RE: Project No. **143120-4 & TMUA-W 16-43**
MINGO & CATFISH CREEKS CHANNEL IMPROVEMENTS

ADDENDUM NO. 2

ADDENDUM NO. 2
TO
PROJECT NO. 143120-4 & TMUA-W 16-43
MINGO & CATFISH CREEKS CHANNEL IMPROVEMENTS

ADDENDUM NO. 2
TO
MINGO & CATFISH CREEKS CHANNEL IMPROVEMENTS
PROJECT NO. 143120-4, TMUA-16-43

PLAN SCALE	DRAWN	SMC	08/2016	APPROVED:
N/A	DESIGNED	EGZ	08/2016	
	SURVEY	PDH	08/2016	
PROFILE SCALE	PROJ. MGR.			
HORIZONTAL: N/A	LEAD ENGR.			
	FIELD MGR.			
VERTICAL: N/A	RECOMMENDED DESIGN MANAGER			CITY ENGINEER
FILE:	DRAWING:			DATE:
ATLAS PAGE NO. 309				SHEET 7a OF 52 SHEETS

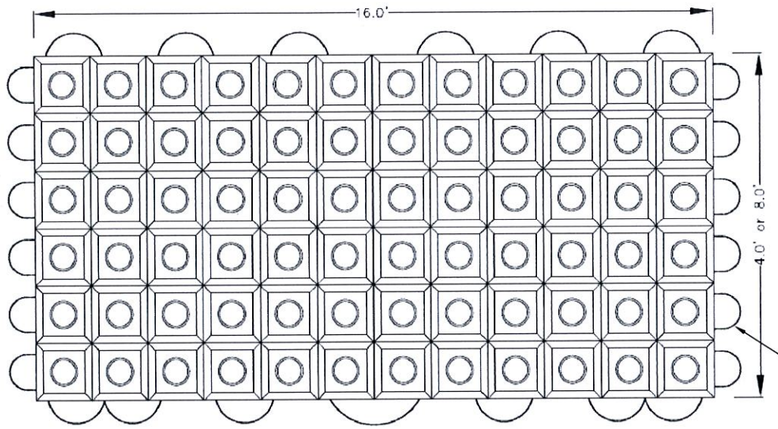
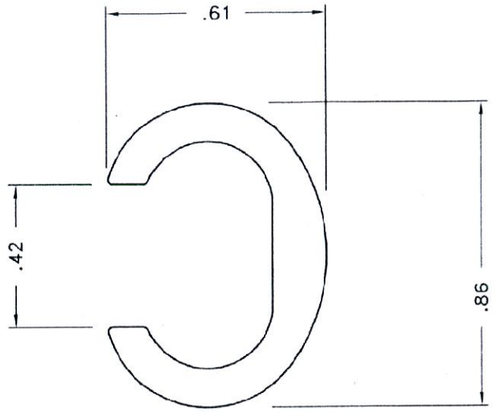
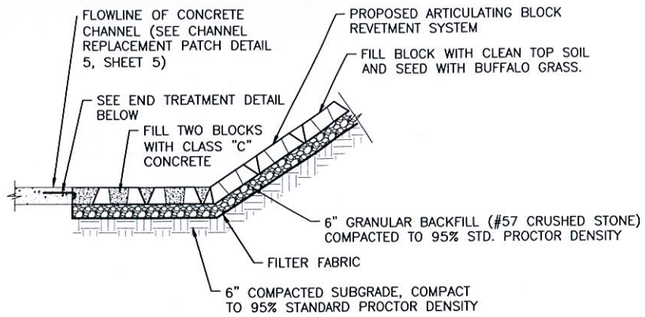
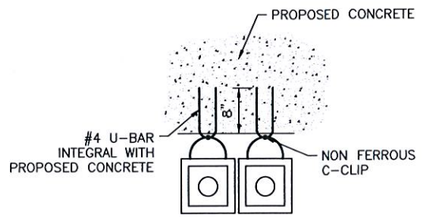
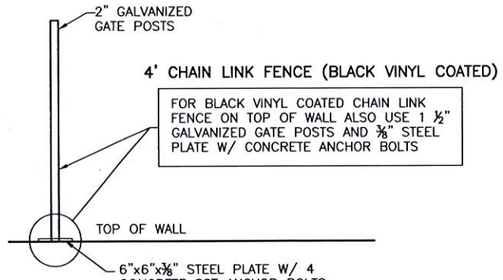
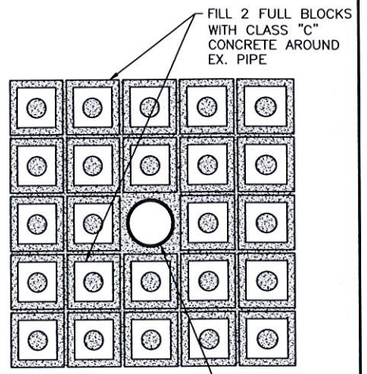
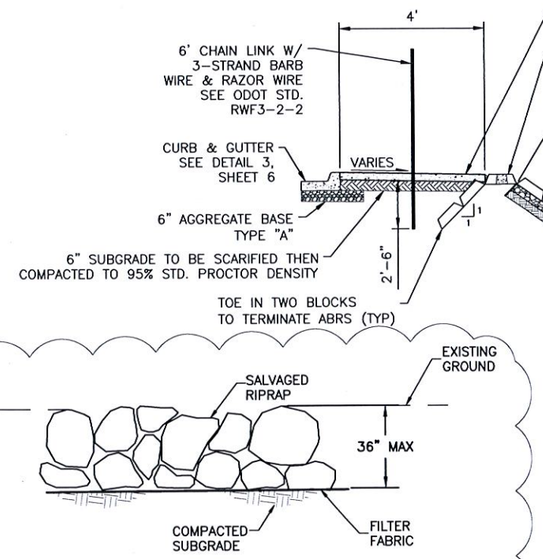
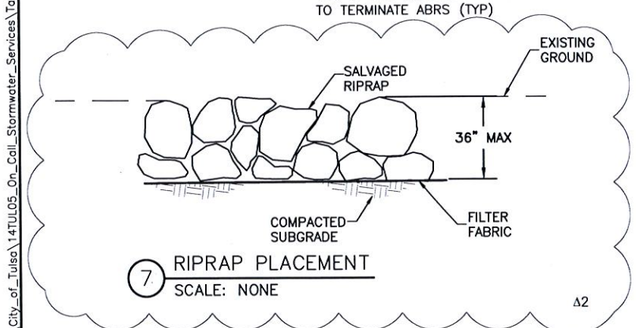
CONTRACTOR TO SUPPLY SHOP DRAWINGS FOR ARTICULATING BLOCK REVETMENT SYSTEM LAYOUT.

RIPRAP PLACEMENT
(7) SCALE: NONE

Δ2
